RE: ROADWAY STABILIZATION, 378 SCENIC ROAD AND 78 WREDEN AVENUE, TOWN PROJECT # 51-813, ADDENDUM NO. 1

ADDENDUM NUMBER 1 (Total number of pages including this page and attachments: 6 Pages)

DETAILS

Storm Damage Repair
78 Wreden Ave
Fairfax, California

1 RETAINING WALL DETAIL (NO SCALE)

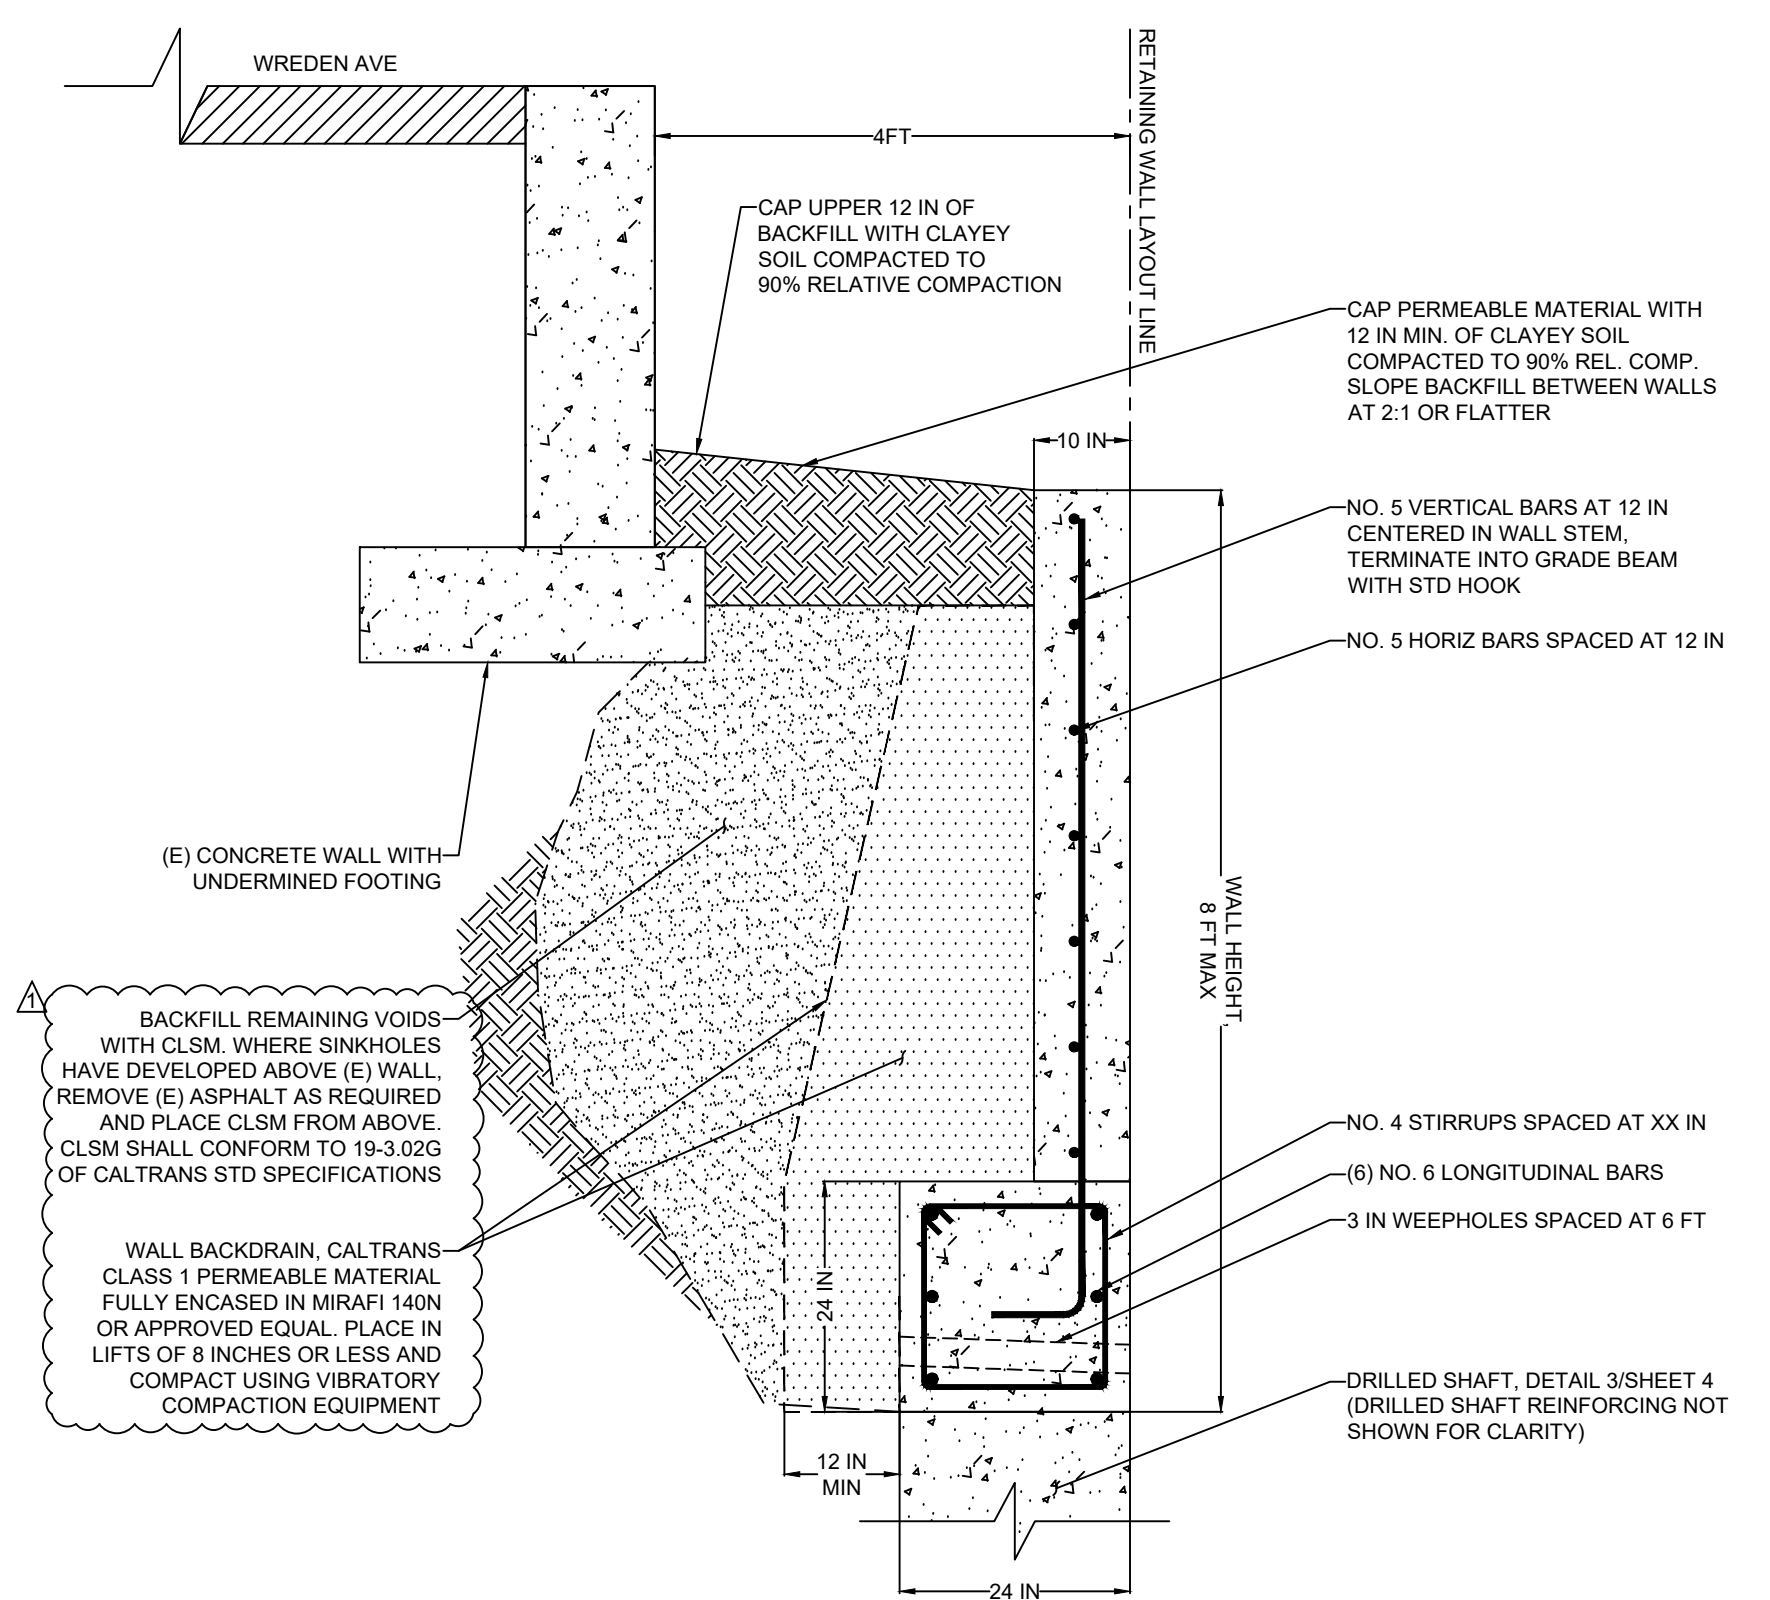
1. The Bid Opening Date has been postponed. Sealed bids will be accepted up to but not later than 2 p.m. on Thursday, September 8, 2022.
2. Detail 1 on Sheet 4 of the plans has been revised to clarify backfilling of voids/sinkholes beneath Wreden Avenue, behind the existing retaining wall (revised Sheet 4 attached).
 - a. Bid item for Controlled Low-Strength Material (CLSM) backfill of voids/sinkholes behind and below the existing wall has been added.
 - b. Bid Schedule B has been replaced in its entirety (revised Bid Schedule attached).

1. How will sinkholes/voids behind the existing wall and beyond the limits of the culvert replacement be backfilled?

Voids shall be backfilled with flowable Controlled Low-Strength Material (CLSM) following construction of the new retaining wall and associated backdrain.
